8XC51RX

SPECIFICATION UPDATE

Release Date: July, 1996

Order Number: 272885-001

Figure 1. Internal and External Data Memory Address Space with EXTRAM = 0

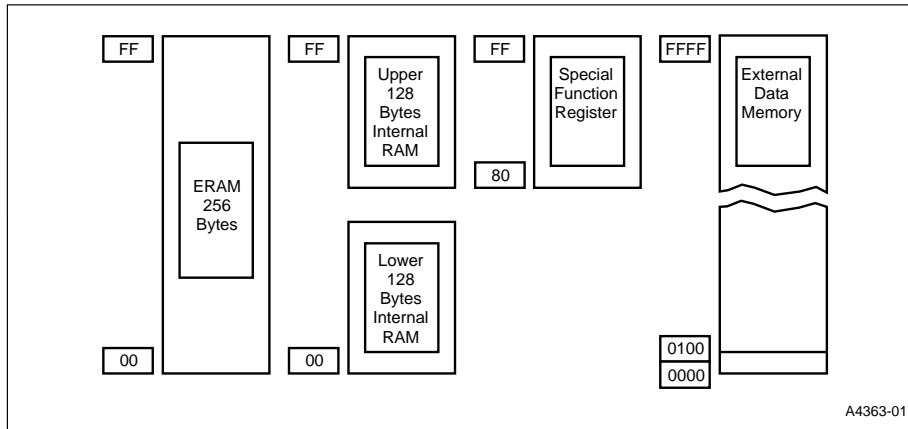
PROBLEM: The default value of EXTRAM bit is 0. To use external memory, customers will need to set the EXTRAM bit to 1.

Figure 1 contains the internal and external memory address space with EXTRAM = 0. This condition accesses the 256 bytes of extended RAM and disables external memory access.
